CPED STAFF REPORT

Prepared for the City Planning Commission
CPC Agenda Item #8
July 20, 2015
BZZ-7225 and RLS-79

Project Name: Downtown East Phase II – Radisson Red

Request: To construct a new hotel.

R:\Projects\700\500\700-512 Downtown East Block 69 North Parcel (Radission Red)\CIVIL_dwg Sheet Files\SITE PLAN.dwg

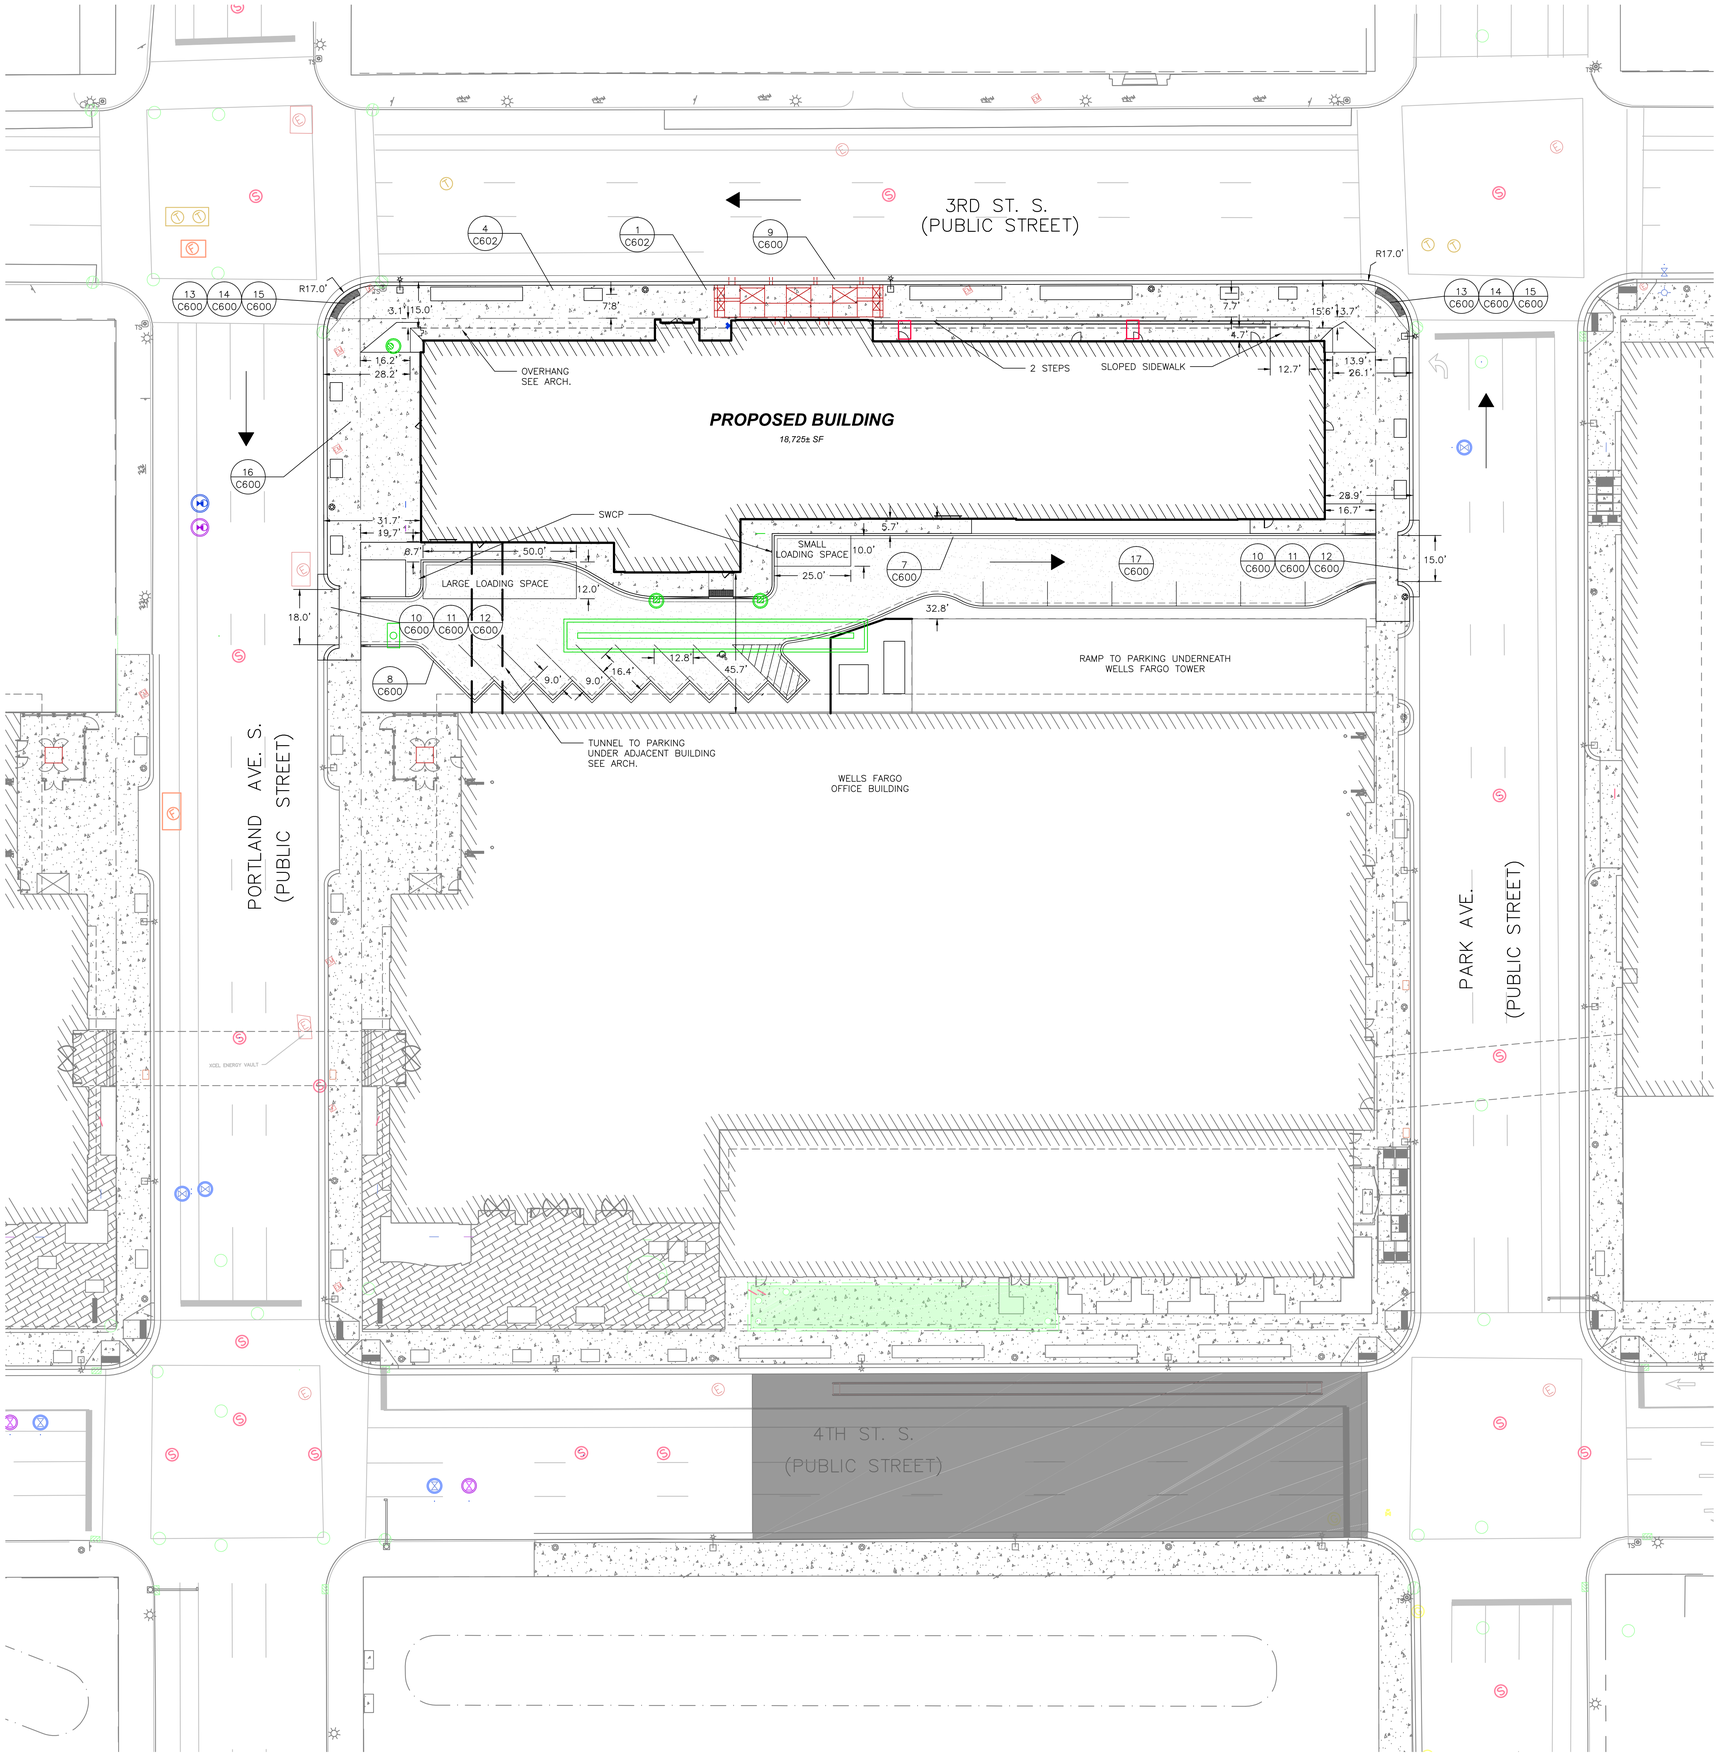
- Note to the Applicant: Per the Minneapolis Code of Ordinances, permanent encroachments into the Public right-of-way are limited; Sheet C300 of the Site Plan indicates various easements into the Public right-of-way along 3rd St S.; the Applicant shall provide an explanation for the noted easements.

- Per the Minneapolis Code of Ordinances, out-swinging doors are permitted to encroach a maximum of 4" into the Public right-of-way. The site plan indicates doorways along 3rd St. S. that swing into the Public right-of-way. The Applicant should consider designs that provide for in-swinging doors or recessed doorways to prevent out-swinging doors beyond the maximum allowable encroachment.
